CHR International Inc.
3553A Industrial Park Drive
Marianna, Florida 32446 USA
www.SafariHelicopter.com
850.482.4141
FAX 850.482.4646

MI-003 Horizontal Stabilizer Mandatory Inspection and Modification

April 6, 2015

Area to be inspected:

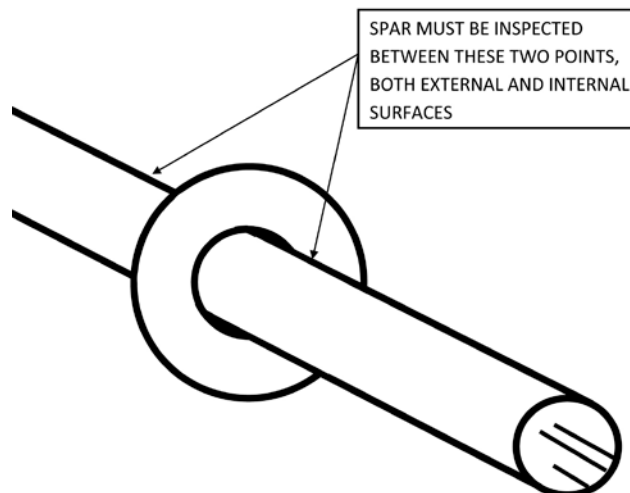
We have observed evidence of fatigue cracking at the location of a horizontal stabilizer positioning flange, which has the potential to break in flight.

In manufacturing the center tube of the horizontal stabilizer, a circular flange of 4130 Chromoly steel is slid onto the tube and welded in place. This is matched to a slightly larger piece of tubing and flange which is welded to the tail boom.

It is necessary to remove the horizontal stabilizer and inspect the interior and exterior of the tube at the location of the circular flange. Unless the sheet metal that forms the horizontal stabilizer wing is attached at adequate distance from the flange to allow inspection, the sheet metal skin must be removed to inspect the flange on the outboard side.

If no evidence of fatigue cracking is found, an 8 inch insert of 7/8" x .058" 4130 Chromoly steel tubing must be installed into the end of the stabilizer to extend the full length of the tail boom mount. This insert should extend between the second and third rivet that secures the sheet metal of the stabilizer to the center tube and must be welded to the center tube at the end of the spar. Rivets which are removed to allow installation of the insert should be replaced with Cherry Max or AN470AD-4-5 hard rivets. The sheet metal should be modified if necessary for it to be positioned far enough away from the welded flange to allow future inspections without disassembling the stabilizer.

If fatigue cracking is found, the horizontal stabilizer spar must be replaced with a new spar which includes the required insert.
